Project	IEEE 802.16 Broadband Wireless Access Working Group < <a href="http://ieee802.org/16">http://ieee802.org/16</a> >	
Title	Service Primitive for Paging Group Action	
Date Submitted	2005-07-19	
Source(s)	Jee Hyeon Na, Yun Won Chung, PhD Sang Ho Lee, PhD ETRI, 161, Gajeong-dong, Yuseong-gu, Daejeon, 305-700, Korea	<a href="mailto:jhna@etri.re.kr">jhna@etri.re.kr</a> <a href="mailto:yun.chung@etri.re.kr">yun.chung@etri.re.kr</a> <a href="mailto:leesh@etri.re.kr">leesh@etri.re.kr</a> Voice: +82-42-860-5408 Fax: +82-42-861-1966
Re:	Call for Comment on P802.16g Baseline Document	
Abstract	This contribution proposes service primitive for paging group action	
Purpose	The document should be considered during the resolution of comments on the baseline document.	
Notice	This document has been prepared to assist IEEE 802.16. It is offered as a basis for discussion and is not binding on the contributing individual(s) or organization(s). The material in this document is subject to change in form and content after further study. The contributor(s) reserve(s) the right to add, amend or withdraw material contained herein.

# Service Primitive for Paging Group Action

Fig. 2 - Paging Group Action Primitive

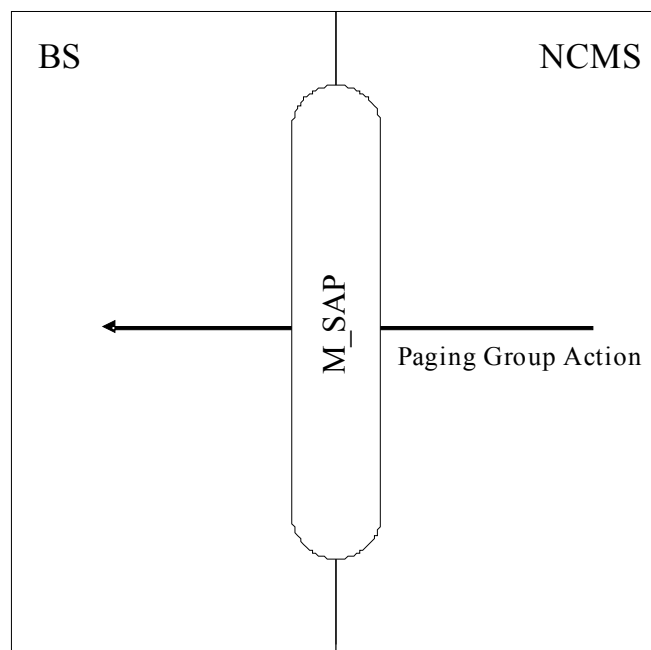
[Modify section 14.5.9.2 as follow]

The location information of an idle MSS is managed by the unit of Paging Group in Paging Service of an NCMS, and paging messages are sent to all the BSs within the called MSS's Paging Group. The NCMS should divide the whole service area into multiple Paging Groups and notify this Paging Group information to all the BSs within the service area, where a BS may be a member of one or more Paging Groups. In this contribution, we propose service primitive for Paging Group Action which is exchanged through Management Service Access Point (M-SAP) of Management Plane specified in IEEE 802.16g baseline document. Paging Group Action is performed by Paging Service of an NCMS, as shown in Fig. 2
